STATE OF MAINE  
 DEPARTMENT OF TRANSPORTATION  
 16 STATE HOUSE STATION  
 AUGUSTA, MAINE  
 04333-0016

October 29, 2009  
 Subject: **Trenton, Acadia Welcome Center**  
 Federal Project No. 16123.50  
 State Pin No.016123.50  
**Amendment No. 4**

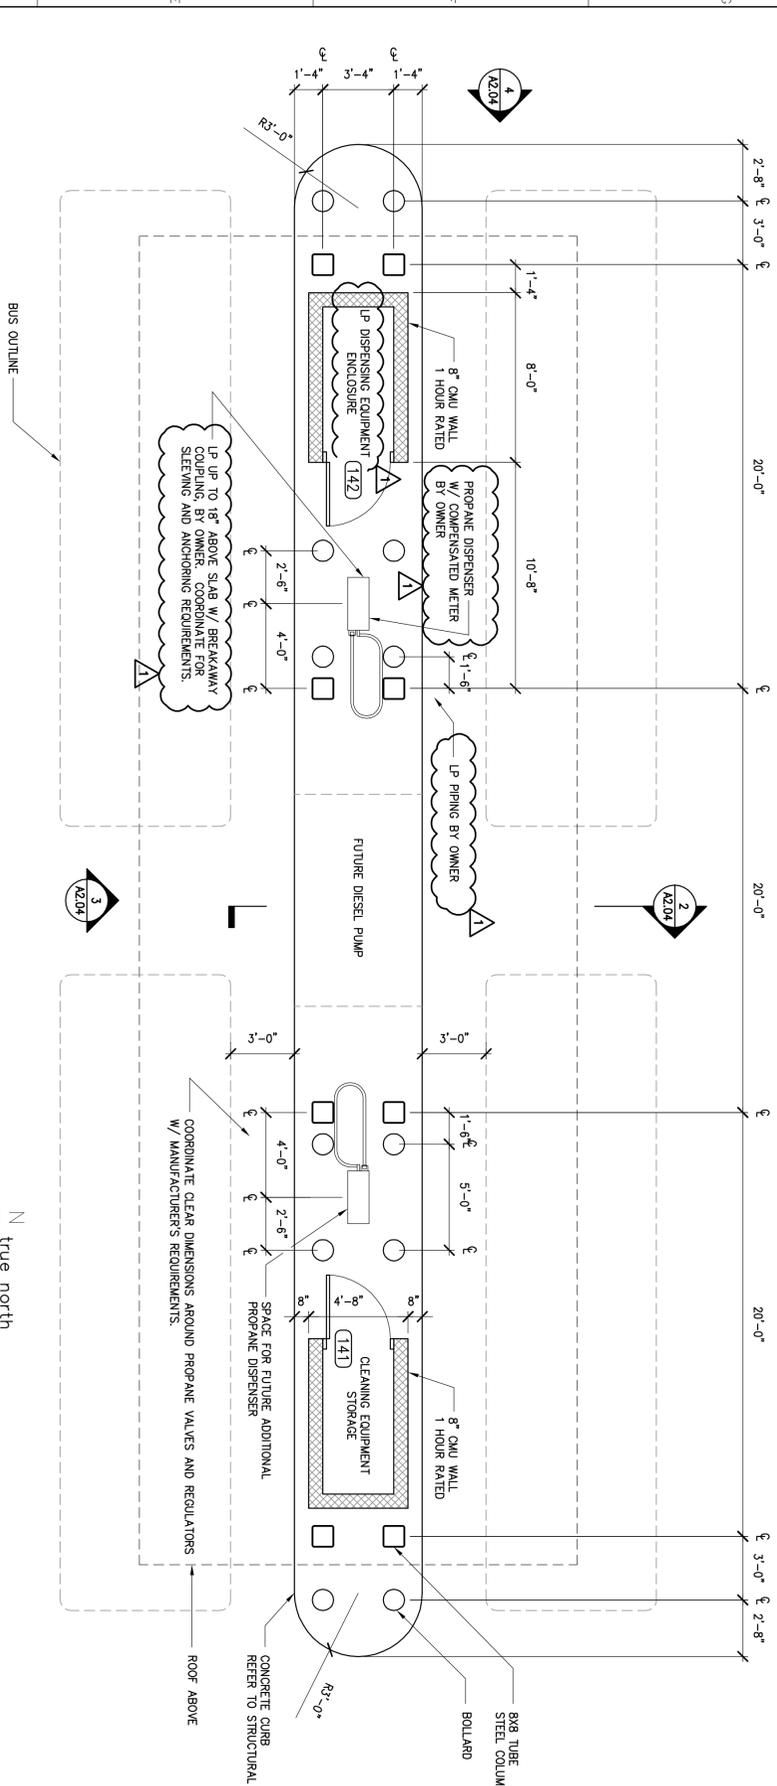
- A. **DELETE** Sheet C-101 in its entirety. **ADD** in its place Sheet C-101, attached, revised and re-issued for Amendment #4.
- B. **DELETE** Sheet C-102 in its entirety. **ADD** in its place Sheet C-102, attached, revised and re-issued for Amendment #4.
- C. **DELETE** Sheet A-2.04 in its entirety. **ADD** in its place Sheet A-2.04, attached, revised and re-issued for Amendment #4.
- D. **DELETE** Sheet A-3.01 in its entirety. **ADD** in its place Sheet A-A-3.01, attached, revised and re-issued for Amendment #4.
- E. **DELETE** Sheet A-7.06 in its entirety. **ADD** in its place Sheet A-7.06, attached, revised and re-issued for Amendment #4.
- F. **DELETE** Sheet A-7.16 in its entirety. **ADD** in its place Sheet A-7.16, attached, revised and re-issued for Amendment #4.

**Response:** Drawing C-101 depicts a match line, all work on the building side of the match line and site utilities that are depicted on ES100 through ES 102 are specific to building divisions, with the exception of Key Botanical schedules on C-57 and C 58 that are covered under their respective pay items.

SHEET NUMBER  
**A2.04**  
OF

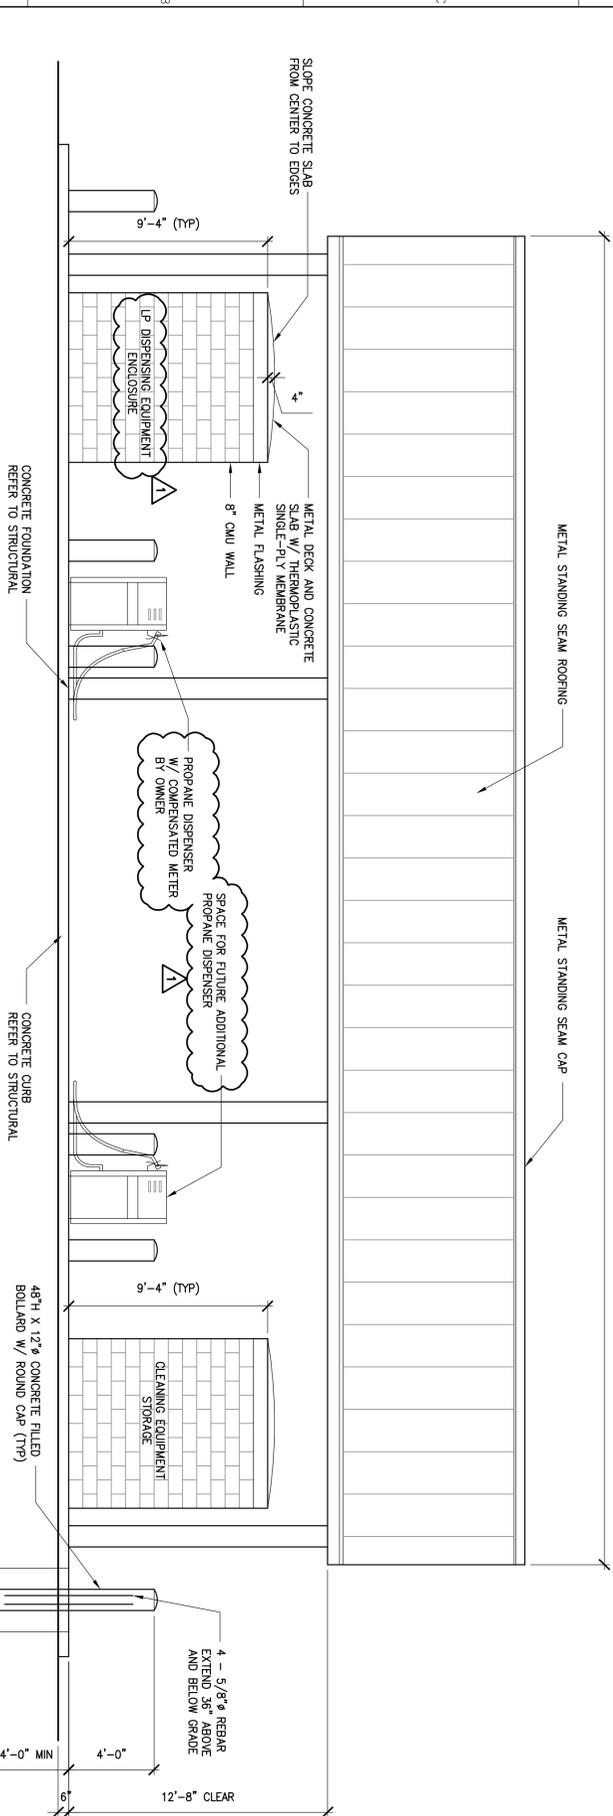
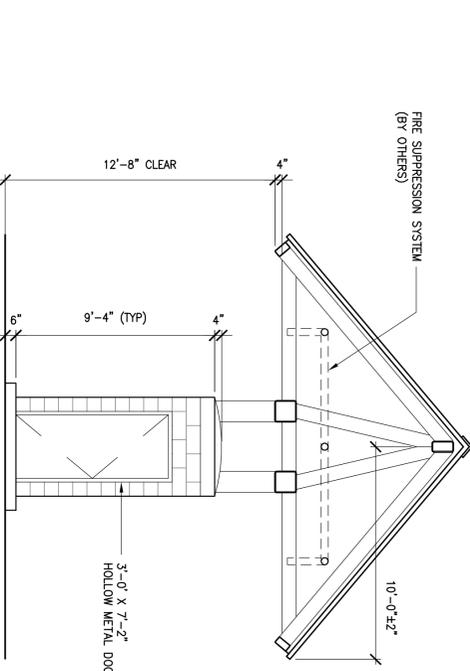
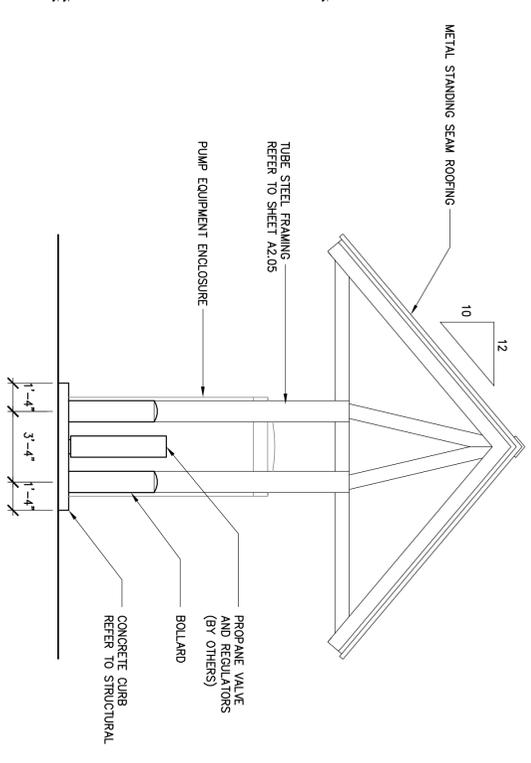
**Response:** Yes, it is correct to assume that the fueling station steel and bus shelter steel is galvanized as well. On A2.04, in the Fuel Station Notes at upper right corner of the sheet, we ask for the steel to be hot-dipped galvanized and painted. The same note appears on A2.06 on the Bus Station notes. We also ask for all connections to be welded. Steel assemblies can be largely prefabricated and delivered to the site, with minimum welding of the sub-assemblies on-site; most priming and painting can be undertaken in the shop. However, the welds would have to be ground smooth and a zinc-rich primer (re-galvanizing) applied on the site, then touch-up painted.
